ITEM 30

CONCEPT PLAN REVIEW FOR CLOVERCROFT ESTATES SUBDIVISION, CONTAINING 40 LOTS ON 204 ACRES LOCATED OFF CLOVERCROFT ROAD IN THE 4TH VOTING DISTRICT (1-2025-211).

| File Number | (1-2025-211) | |

C201
SITE LAYOUT

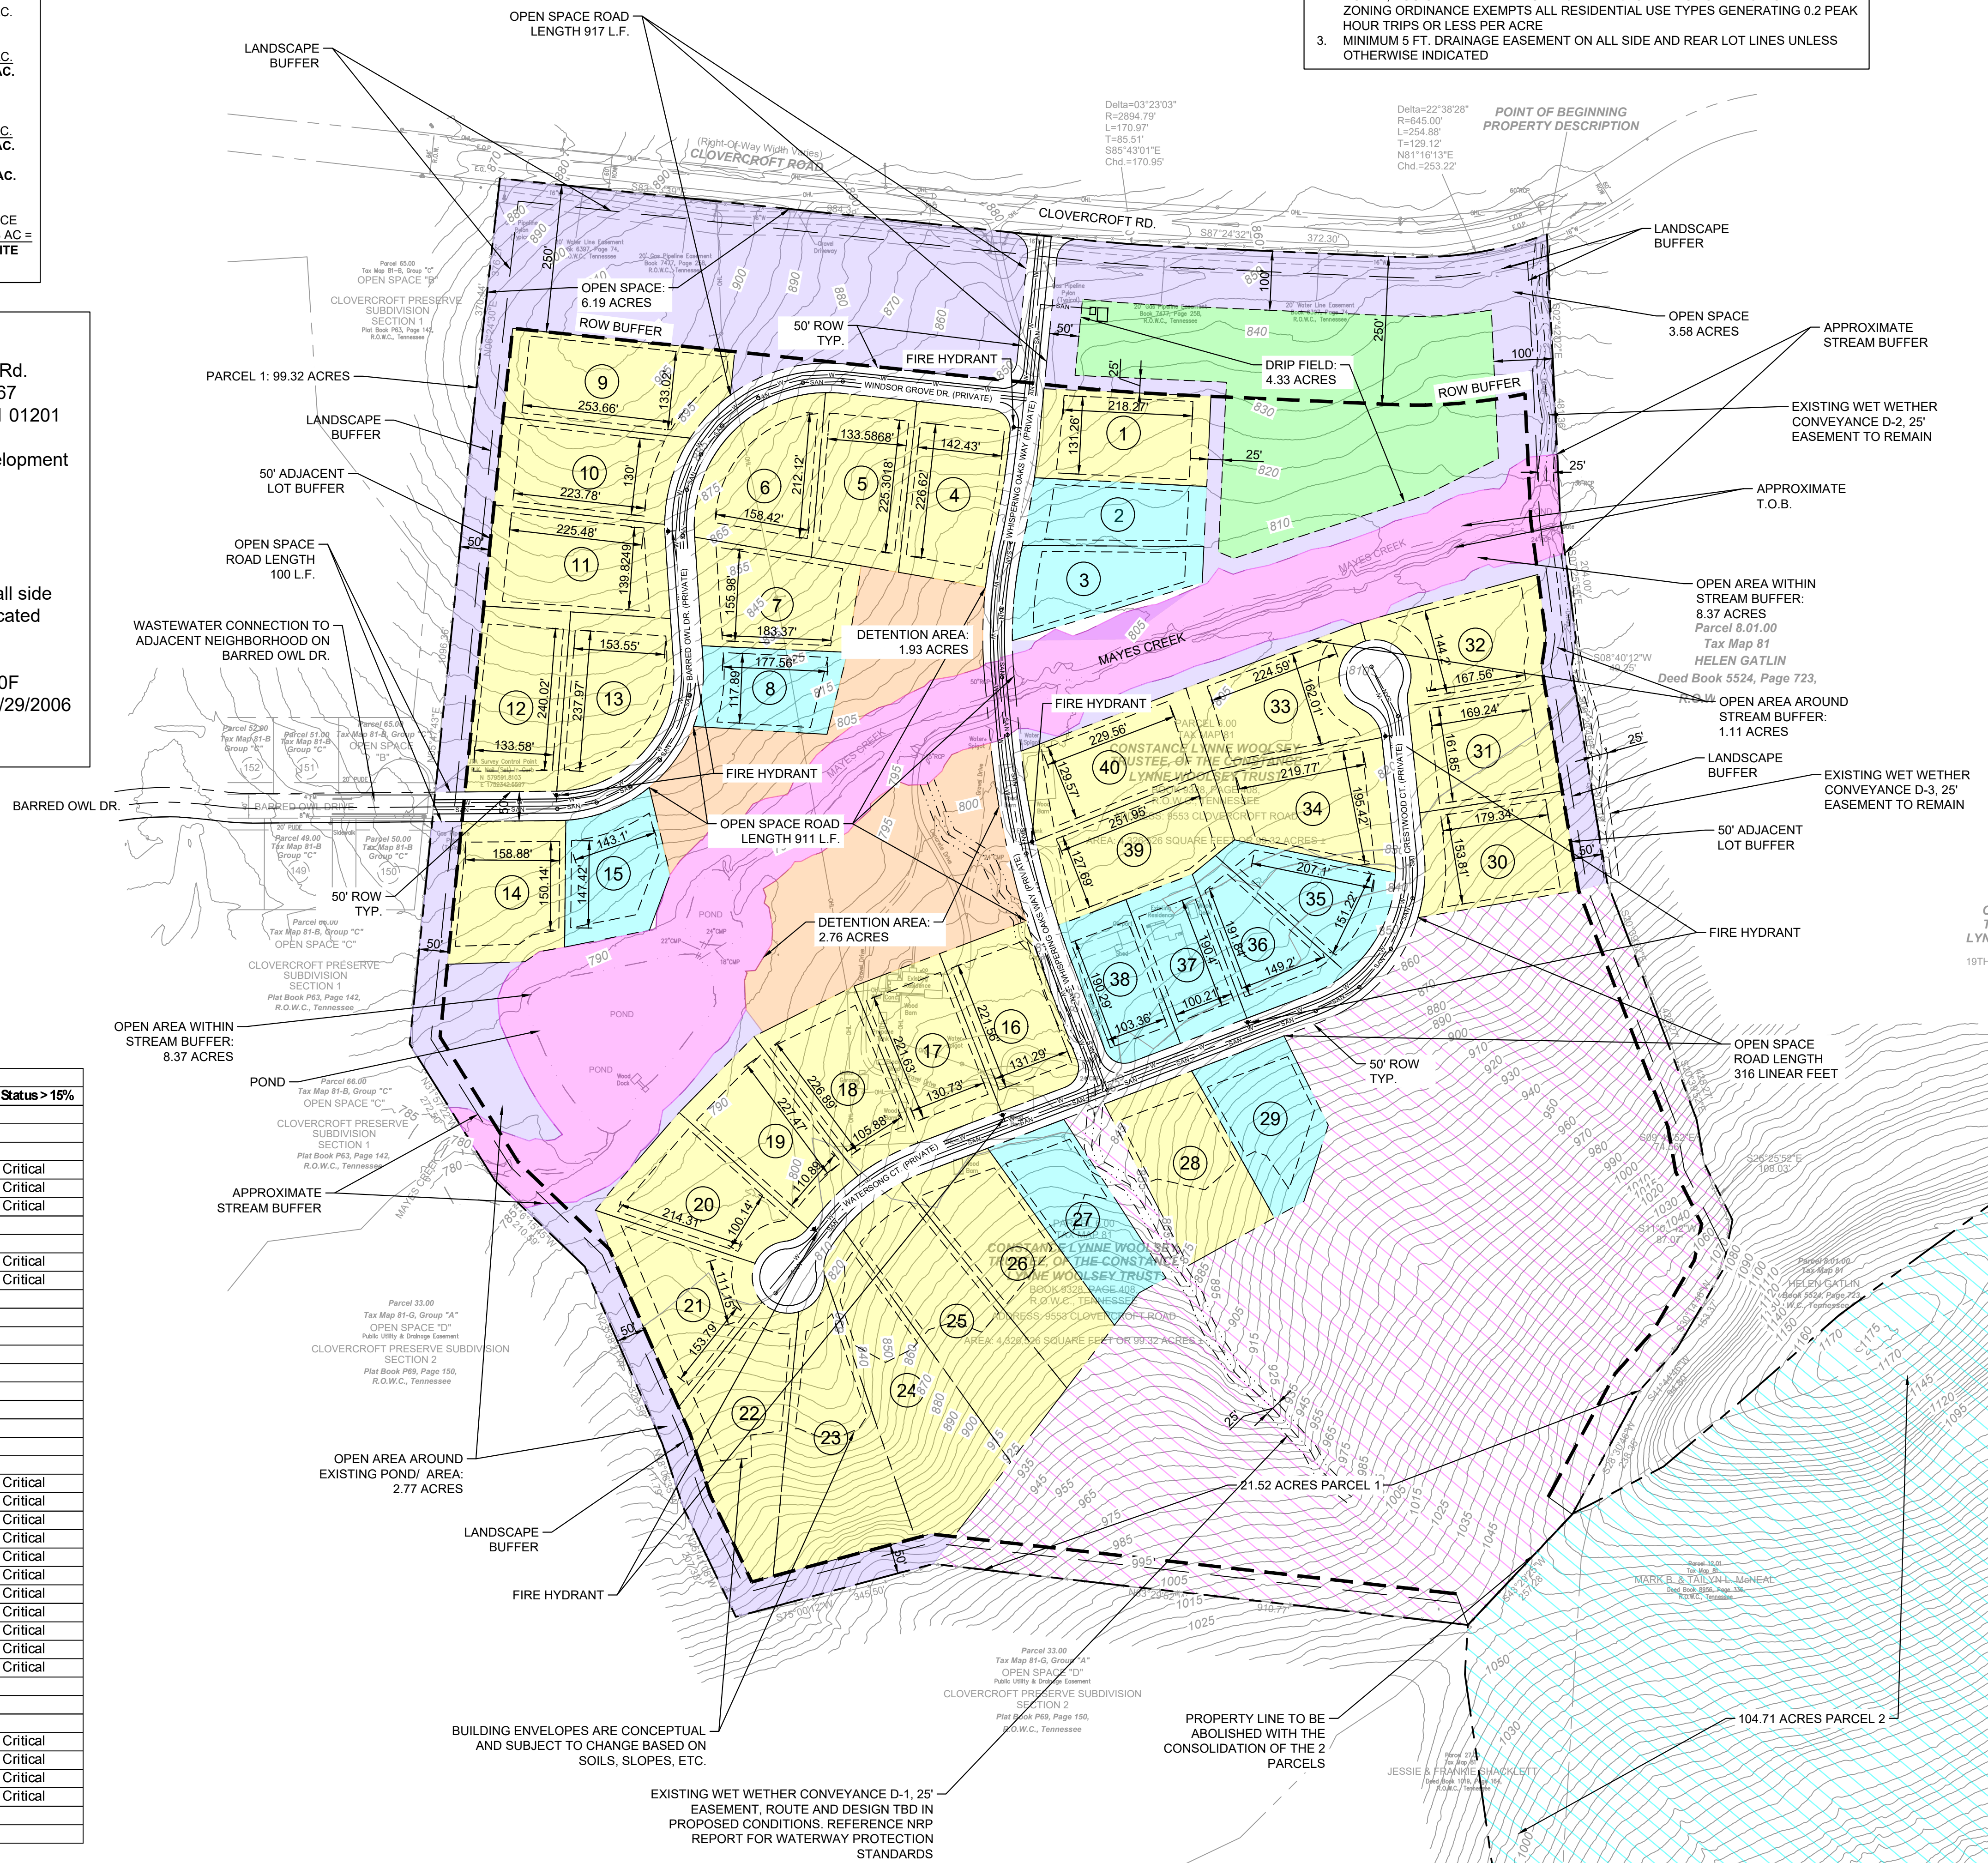
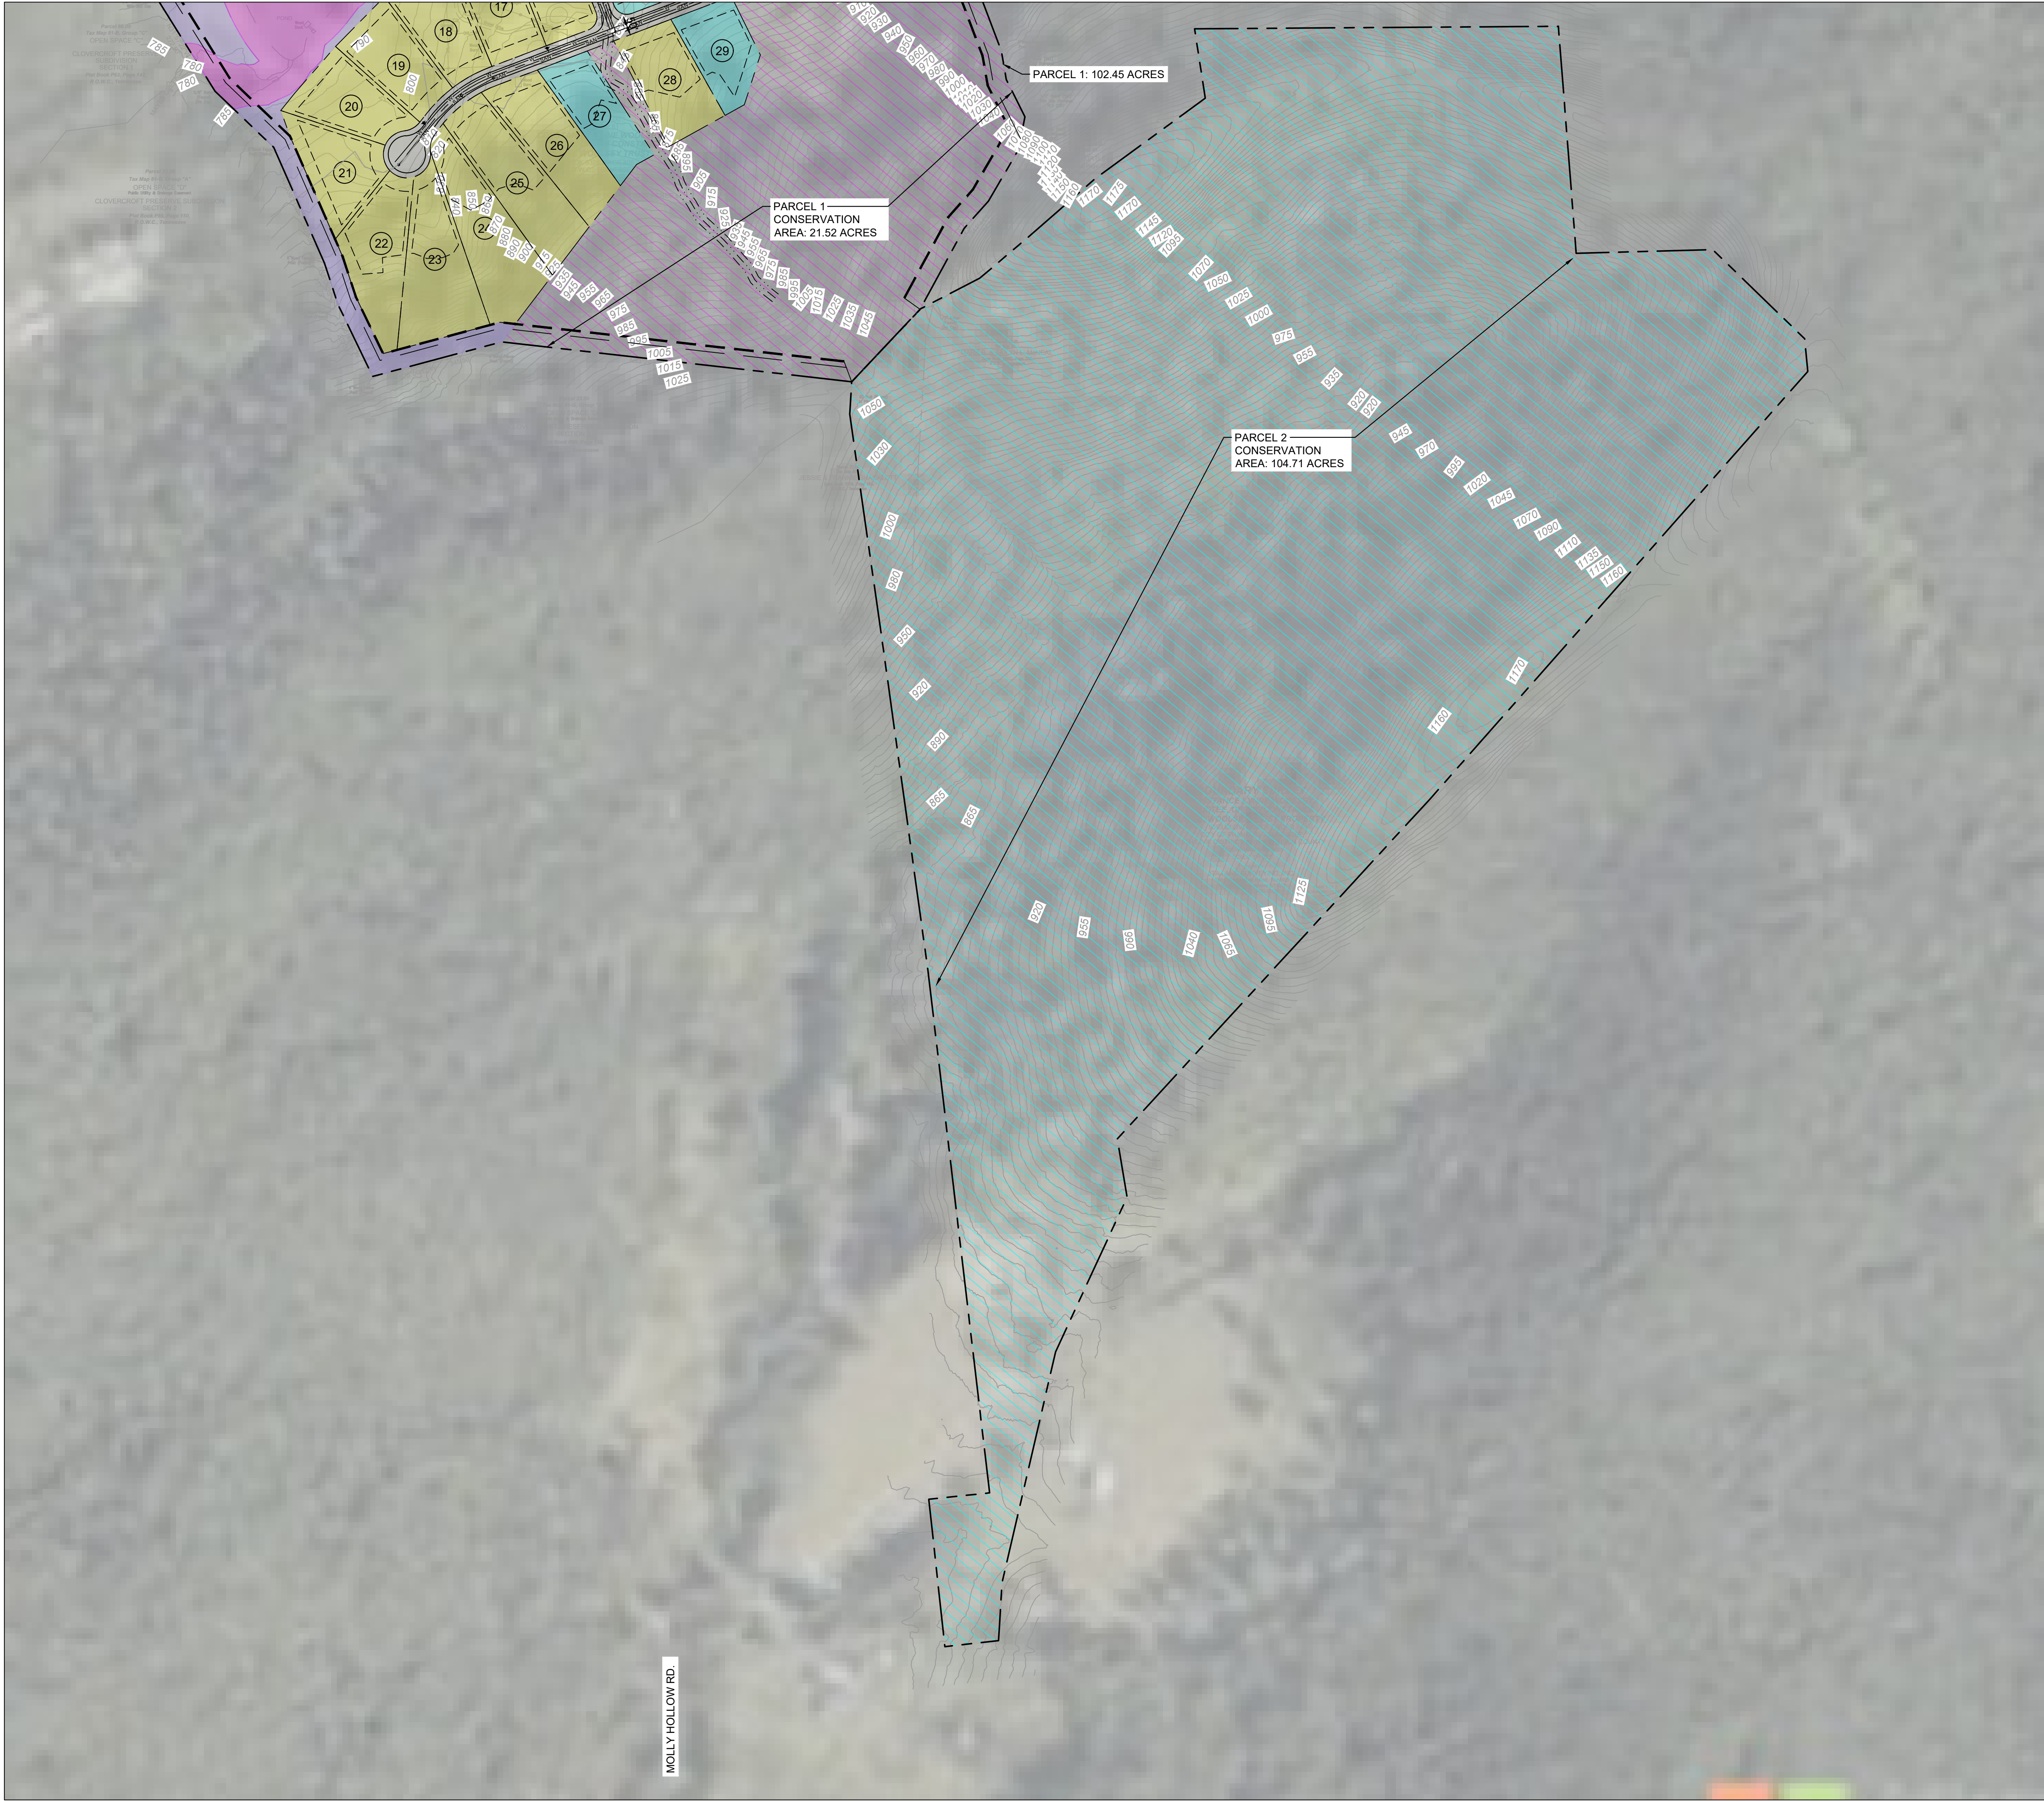
| Williamson County Community Development Aaron Holmes 12/17/25 2:02 PM Conservation Concept Plan - 1 | Presently this development does not have an approved means of Wastewater Treatment and Disposal. As this development is connecting to the Wastewater Treatment and Disposal system currently serving the adjoining development, i.e. Clovercroft Preserve, a revised wastewater site plan for said system, which includes a revision to the DDR and DSIR, a revision of the CCN, and a revision to the draft State Operating Permit, is required. The revision to Site Plan for this Wastewater Treatment and Disposal System will require Planning Commission approval (which may be done on the same agenda as the Concept Plan). A pre-application meeting will be required prior to the submission of the Site Plan. [Ver. 3] [Edited By Aaron Holmes] |

| Williamson County Community Development Aaron Holmes 12/23/25 9:57 AM Conservation Concept Plan - 2 | Article 20, Section 20.05 (A)(3)(b) requires a Wastewater Site Plan for this use be approved prior to consideration of the Concept Plan. As noted above, this development is connecting to the Wastewater Treatment and Disposal system currently serving the adjoining development, i.e. Clovercroft Preserve, a revised wastewater site plan for said system, which includes a revision to the DDR and DSIR, a revision of the CCN, and a revision to the draft State Operating Permit, is required. The revision to Site Plan for this Wastewater Treatment and Disposal System will require Planning Commission approval (which may be done on the same agenda as the Concept Plan). A pre-application meeting will be required prior to the submission of the Site Plan. [Ver. 2] [Edited By Aaron Holmes] |

| Wilson Engineering Inc. Jeffrey Wilson 12/22/25 4:21 PM Conservation Concept Plan - 1 | <i>Response: In process, we are coordinating with the wastewater utility. Article 20 documentation will be provided at the appropriate wastewater system Site Plan stage.</i> |

Response: The wastewater plan is to convey sanitary waste to the adjacent neighborhood, Clovercroft Preserve, drip field where it will be processed at the Clovercroft Preserve facility. Please reference "Will Serve Letter" from Adenus within the submittal package. The 4.33 acres on our site is designated as reserve drip area. Collection lines will be designed as part of the final construction plans and tanks for each home will be the builders responsibility.
